GENERAL T.I. BULLETIN INDEX

Number	Gn001
(JCB Gen 003)	
Issue	1
Date	March 1990

SUBJECT: Tappet Adjustment

SUBJECT: Rocker Shaft Security

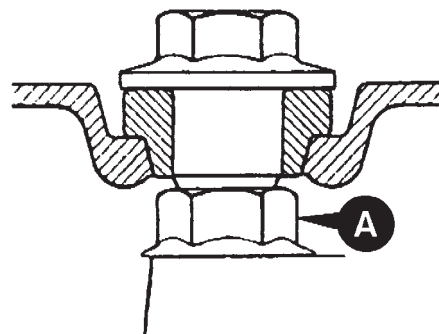
Introduction of new fasteners for the rocker assembly.

Flanged nuts **A** replace the three nuts and washers securing the rocker shaft to the cylinder head. The single bolt and washer is replaced by a flanged bolt.

If the new fasteners are fitted to earlier engines the washers must be removed.

Torque tighten the new fasteners to 40 Nm (30 lbf ft).

02/291060	NUT	replaces	1370/0401Z
02/291048	SET SCREW	replaces	02/291125
02/291064	WASHER	-	Not Required

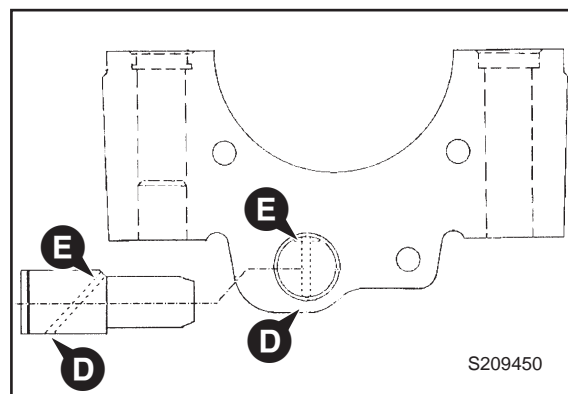
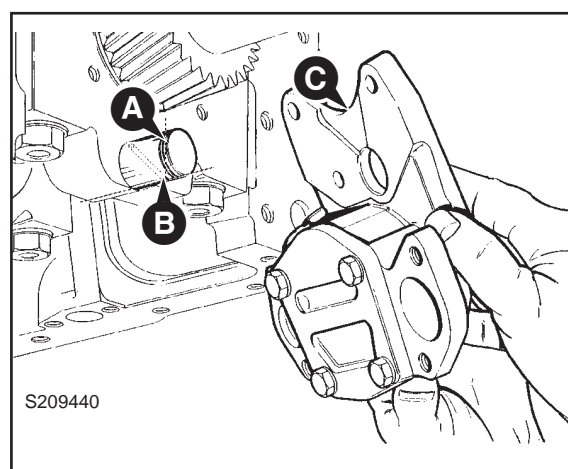
A new idler shaft **A** has been introduced which has an oil hole **B** to provide more lubrication to the bush for the idler gear. Also a new lubricating oil pump has been introduced which has a channel **C** in the body of the pump. Lubricating oil from the front main bearing passes down the channel in the body of the pump to the oil hole in the idler shaft. The lubricating oil then passes through the hole in the idler shaft to the bush in the idler gear.

Part No.	Description	Part No.	Description
02/290006	Bush	02/201050	Pump (4 Cylinder Engines)
02/201131	Shaft	02/201130	Pump (6 Cylinder Engines)
4101/0651	Loctite 648 Retainer

1 AXLES

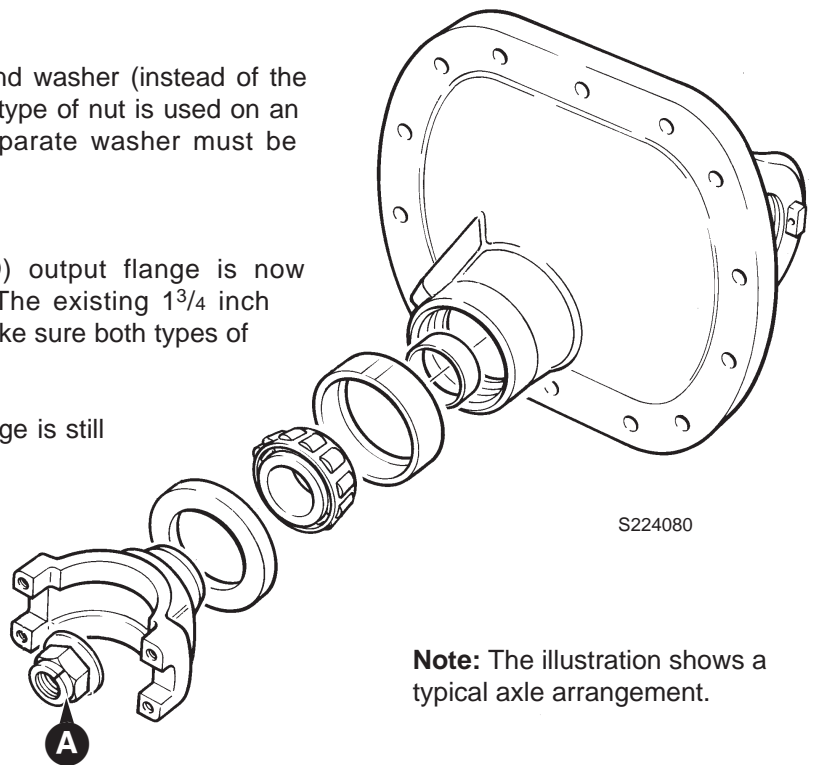
Axle stake nuts **A** are now a combined nut and washer (instead of the separate nut and washer arrangement). If this type of nut is used on an earlier type axle or 4WD flange, the old separate washer must be discarded.

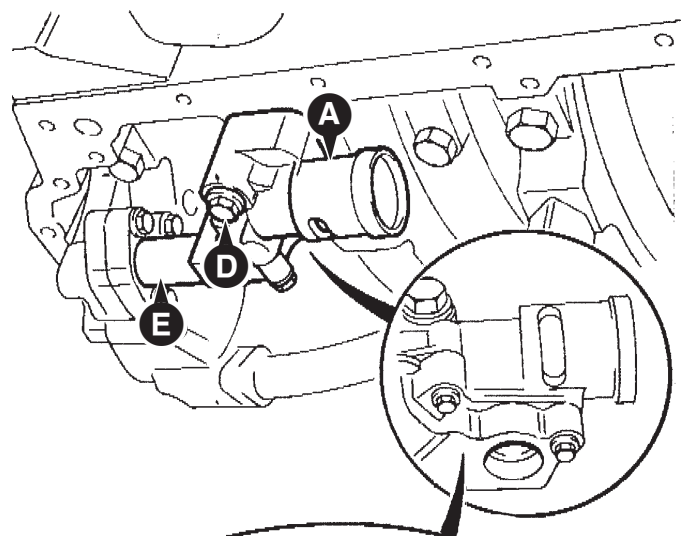
The possibility exists that engine relief valve housing **A** may fail. The relief valve controls the engine lubricating system oil pressure, therefore a failure of the housing could result in the loss of engine oil pressure and cause subsequent damage to the engine.

Investigation has shown that the relief valve housing has been machined incorrectly and remedial procedures have already been implemented to ensure all relief valve housings are now machined to the correct specification.

- 5** Provide a support for the sump and remove the sump retaining bolts. Lower the sump and remove the sealing gasket.
- 6** Inspect the relief valve housing:
- 6.1** Look at the side of the relief valve housing **A** for the manufacturer's number.
- 6.2** If the number has a '1' below it as shown at **B**, then the housing is made to the correct specification, move to step **9**.
- 6.3** If the number has a '2' below it as shown at **C**, then the housing is made to the wrong specification and must be replaced with a new one, move to step **7**.

Important note: Relief valves obtained from service parts stock with a number '2' are manufactured to the correct specification.

- 7** Remove the relief valve housing retaining bolt **D**, and then remove the relief valve housing **A**.
- 8** Fit a new replacement relief valve housing, torque tighten the retaining bolt to 22 Nm (16 lbf ft). Make sure that the 'O' ring at each end of tube **E** are in good condition and securely in place before tightening the retaining bolt.
- 9** Refit the engine sump together with a new gasket. Tighten the sump retaining bolts to 22 Nm (16 lbf ft). Fit the sump drain plug together with a new 'O' ring, torque tighten the plug to 34 Nm (25 lbf ft). Refit the dipstick and dipstick tube.
- 10** Using the engine oil drained at step **3** refill the engine sump, make sure that the engine oil reaches the 'MAX' mark on the dipstick, top up as required.

Product Improvement

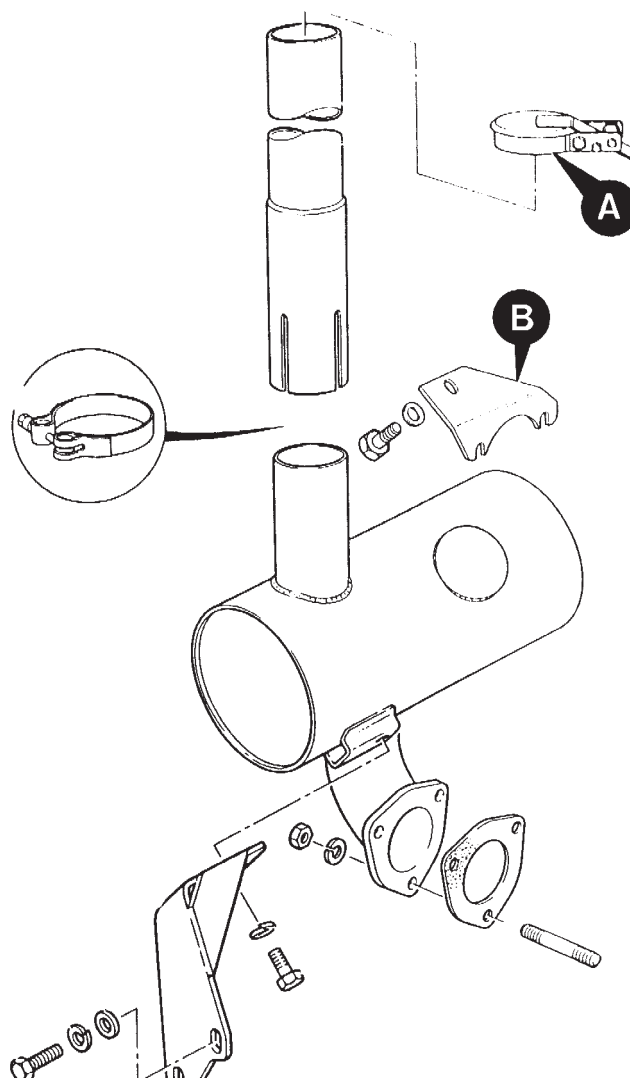
The quality of ITL Silencers has been improved:

1 Turbo Engine Build Silencers

SUBJECT: Change of position for the exhaust manifold alignment bushes

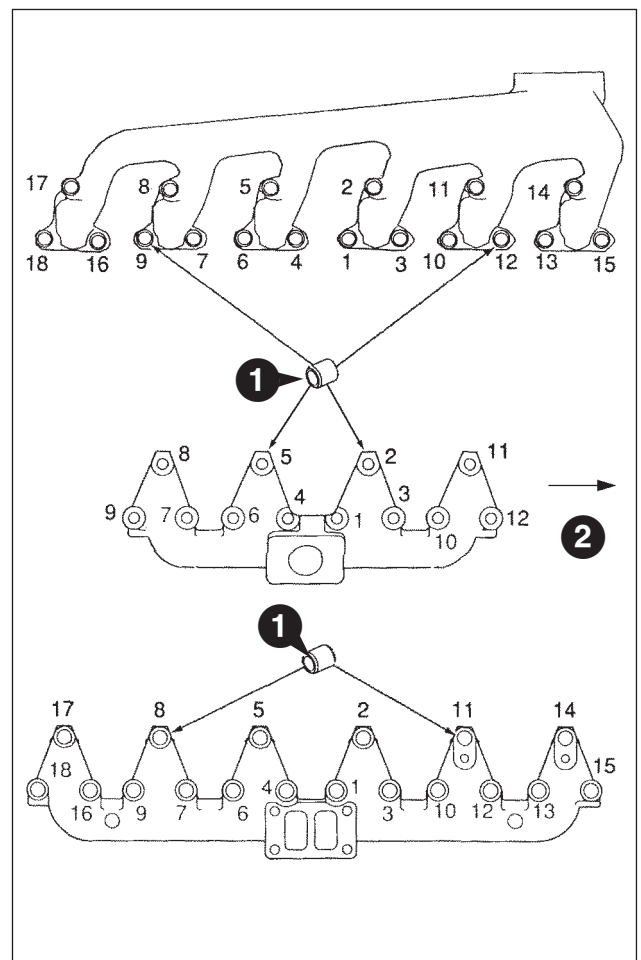
If the manifold is renewed, it is important that the two alignment bushes (1), JCB part number 02/201783 are in position. New alignment bushes are not necessary when the original manifold is removed and fitted.

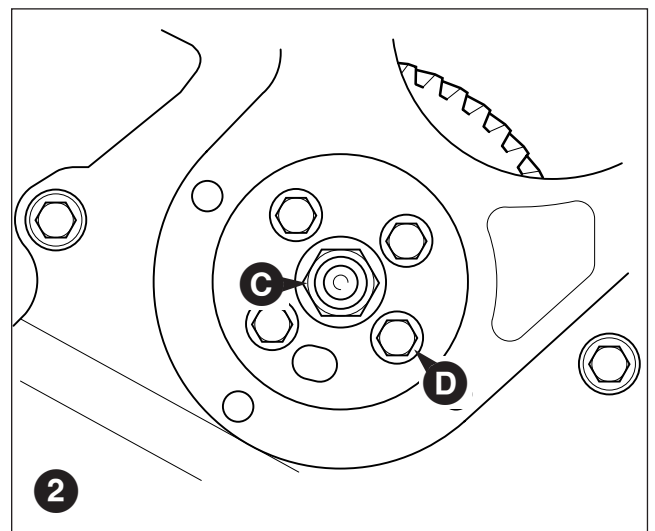
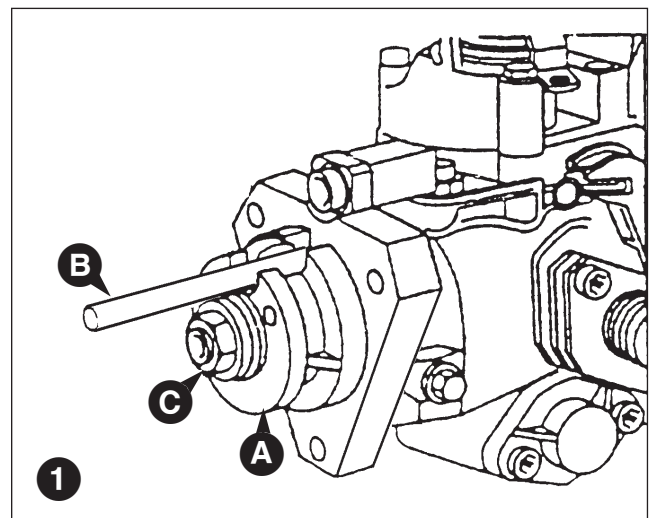
The latest fuel injection pumps have a hub **A** which is mounted permanently onto the drive shaft.

Caution: Do not release the nut **C** from the fuel injection pump. Illustration 2 shows the nut **C** in position when the fuel pump is fitted to the engine. The fuel pump hub is fitted to the shaft in the factory to ensure that the fuel pump is in the correct position for timing. If the nut is removed and the hub moves, the hub will need to be accurately fitted to the pump by use of specialist equipment before the pump can be fitted to the engine.

To remove the fuel injection pump from the engine it is only necessary to remove the four setscrews **D** which secure the fuel pump gear to the hub. It is important to follow the instructions in the workshop manual to ensure the engine timing is correct.

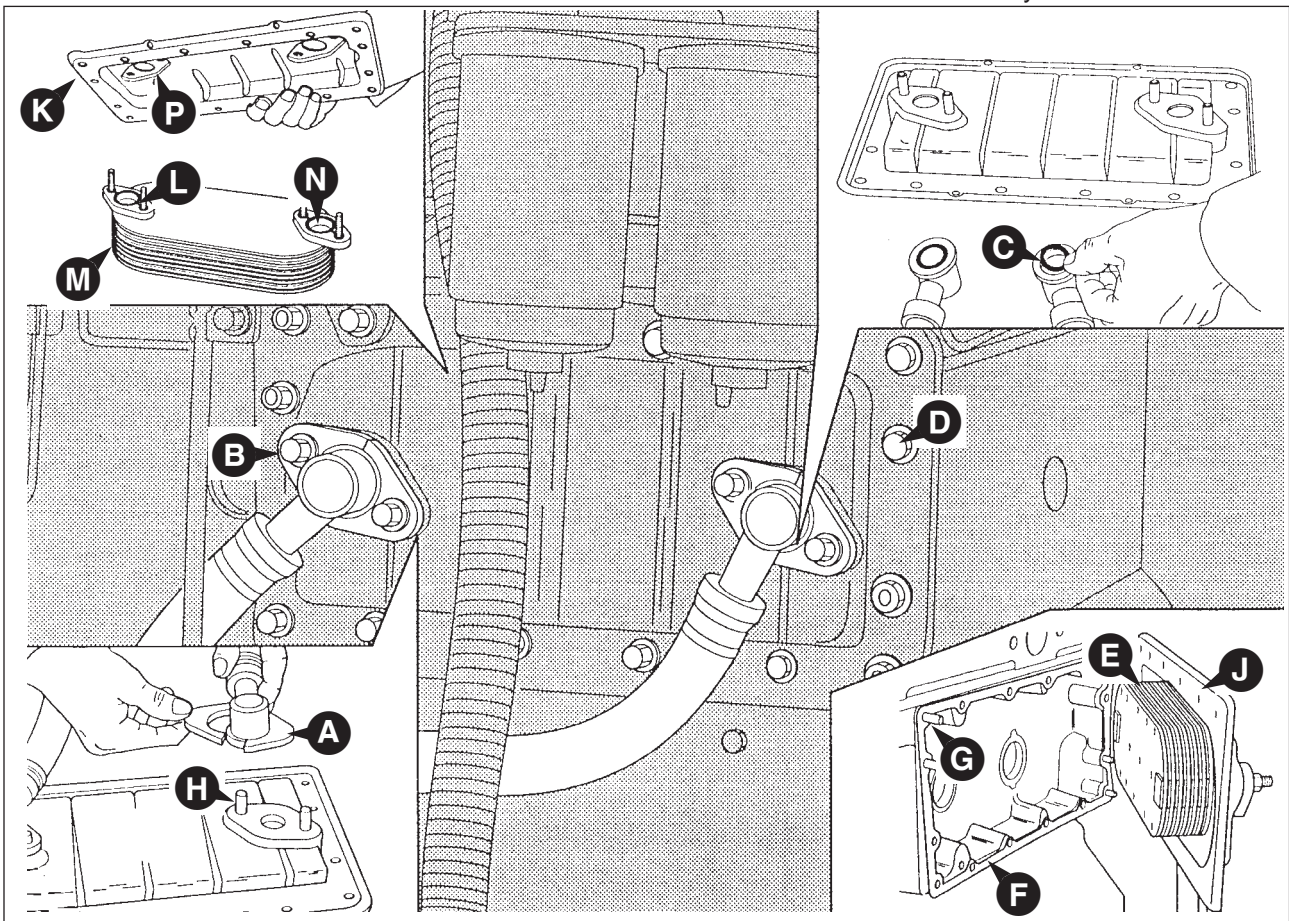
An improved oil cooler with a pressed steel cover has been introduced with effect from engine serial number YB-----U647452C.

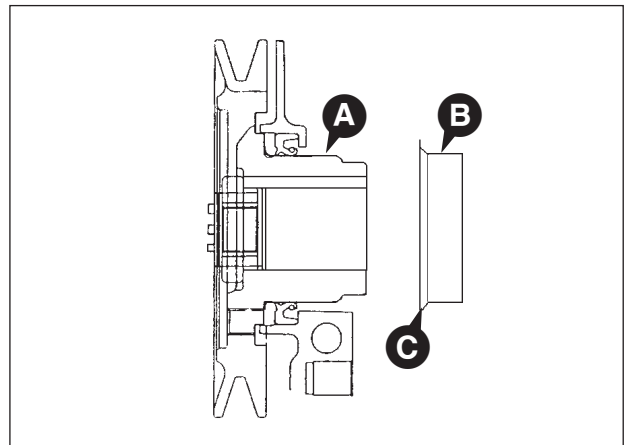
The change improves the efficiency of the oil seal in service and was introduced from engine number:

Caution: If the lip of the oil seal has worn a groove in the spigot **A** of the crankshaft pulley, oil will continue to leak after the new oil seal is fitted.

To renew a worn crankshaft pulley, for engines with the latest timing case, a wear sleeve **B** part number 02/202027 is fitted over the spigot.

The dimension to press the new oil seal into the timing case, with or without a wear sleeve fitted, is 9.3 mm (0.366 in), from the front face of the timing case. The special tool supplied in the kit can be used to set the correct depth.

It is not necessary to remove the flange **C** of the wear sleeve after it has been fitted.

Washers for the Fuel Injection Pump Gear

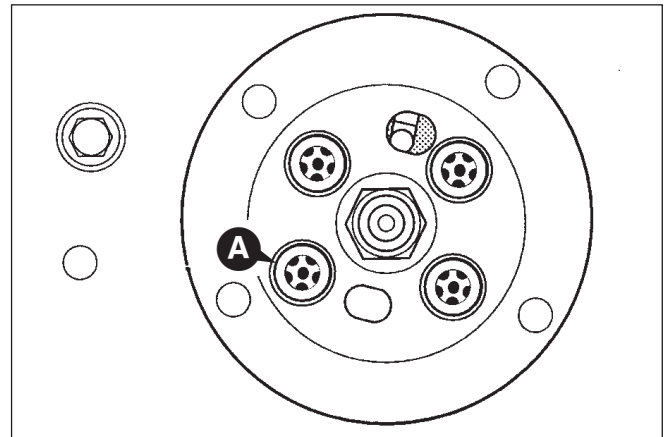
A washer, part number 02/101686, is fitted to each of the screws **A** with effect from the following engine serial numbers:

Caution: Ensure that the washers are fitted before the screws are tightened.

Improved Exhaust Valve Guide

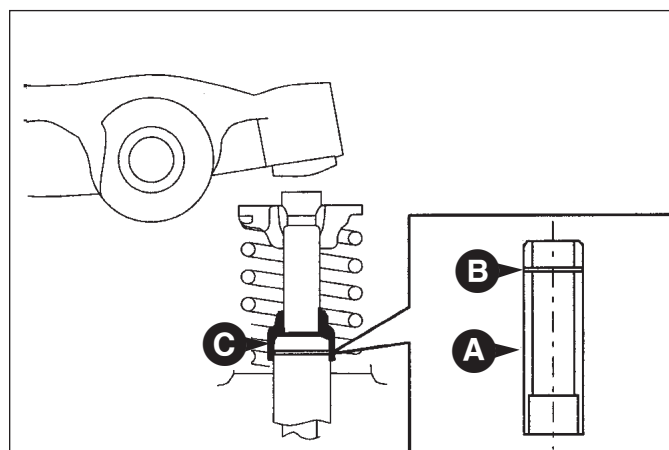
An improved exhaust valve guide **A** has been introduced. The new guide has a groove **B** to retain the valve seal **C**.

To remove and fit the valve guides, refer to Section 12 of the Workshop Manual.

New Perkins Diesel Engine

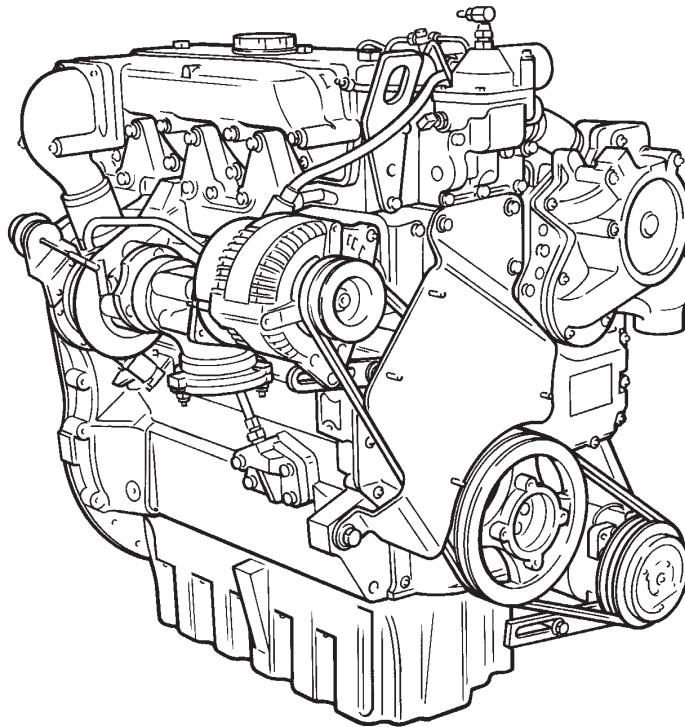
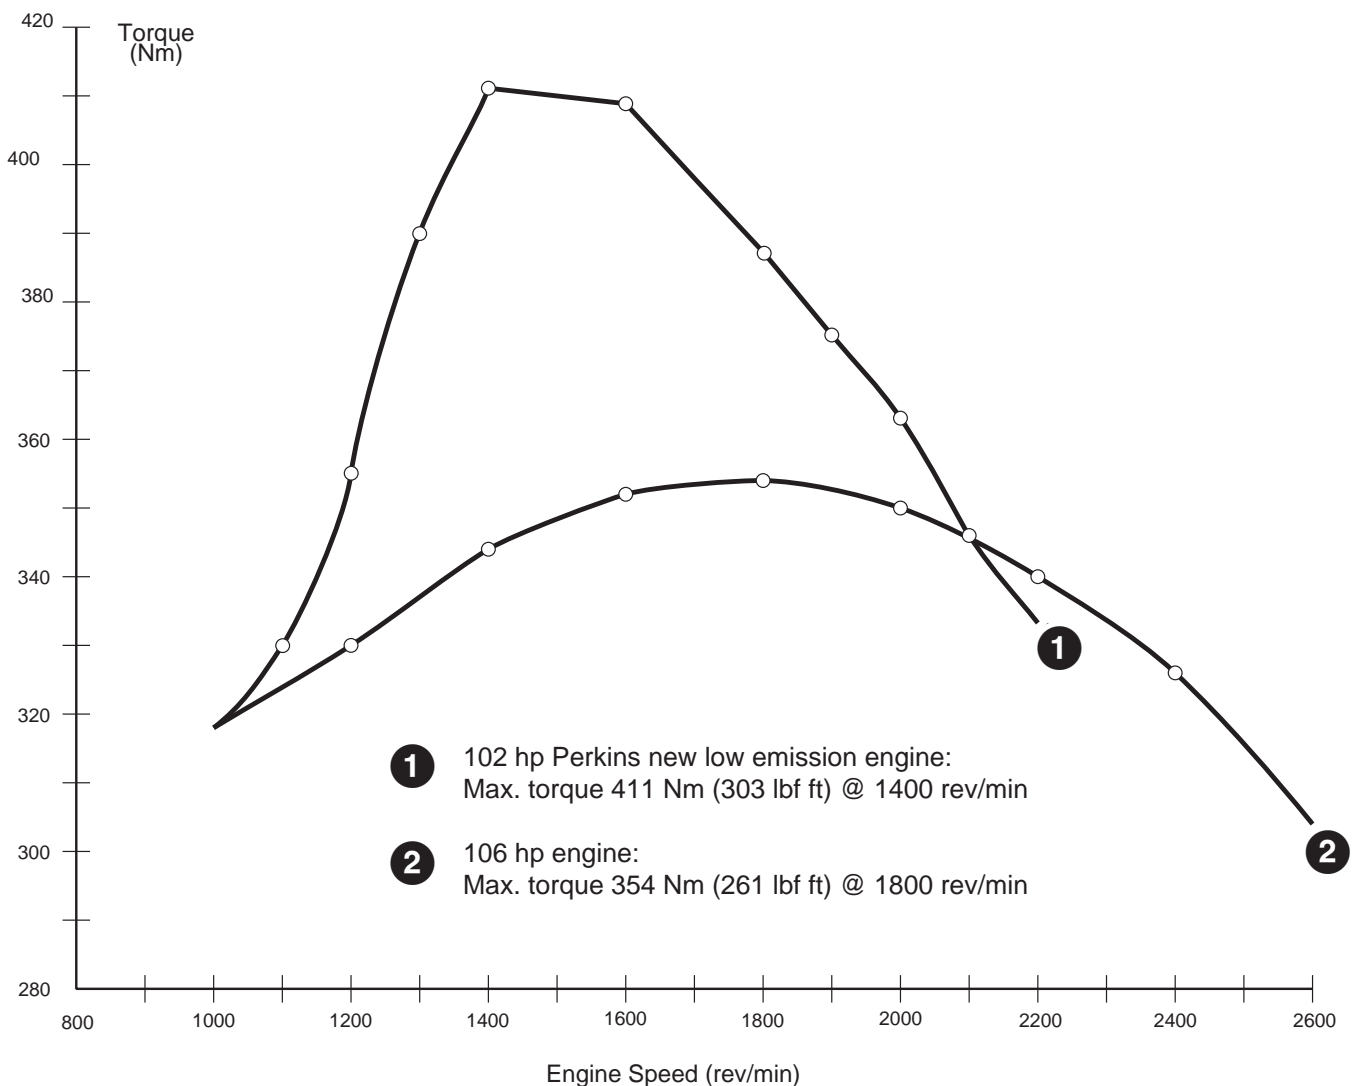
- Improved exhaust emissions
- Wastegated turbo charger
- Improved injection pump
- Increased peak torque
- Improved cold starting performance

The engines comply with mandatory emission legislation and incorporate the following changes:

- Revised cylinder head
- Four branch inlet and exhaust manifolds
- Revised piston design with modified combustion chamber
- Wastegated turbo charger
- Improved fuel injection pump
- Increased compression ratio

The previous 75 hp (56 kW) engine is now updated to 80 hp (59 kW) and develops 290 Nm (214 lbf ft) peak torque.

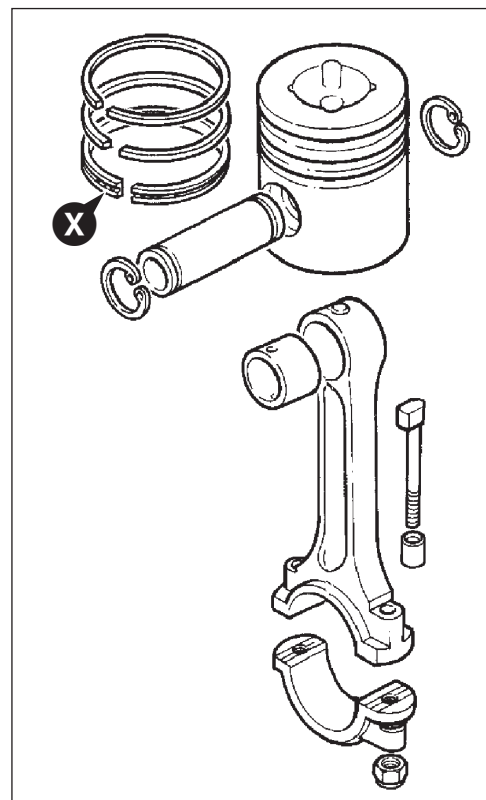
A small taper has been added to the face of the oil control ring to reduce oil consumption during the early life of the engine. The ring is marked 'TOP' on the top face and a blue mark has been added to the left of the ring gap.

Standard	02/201804
0.5 mm oversize	02/201791
1.0 mm oversize	02/201793
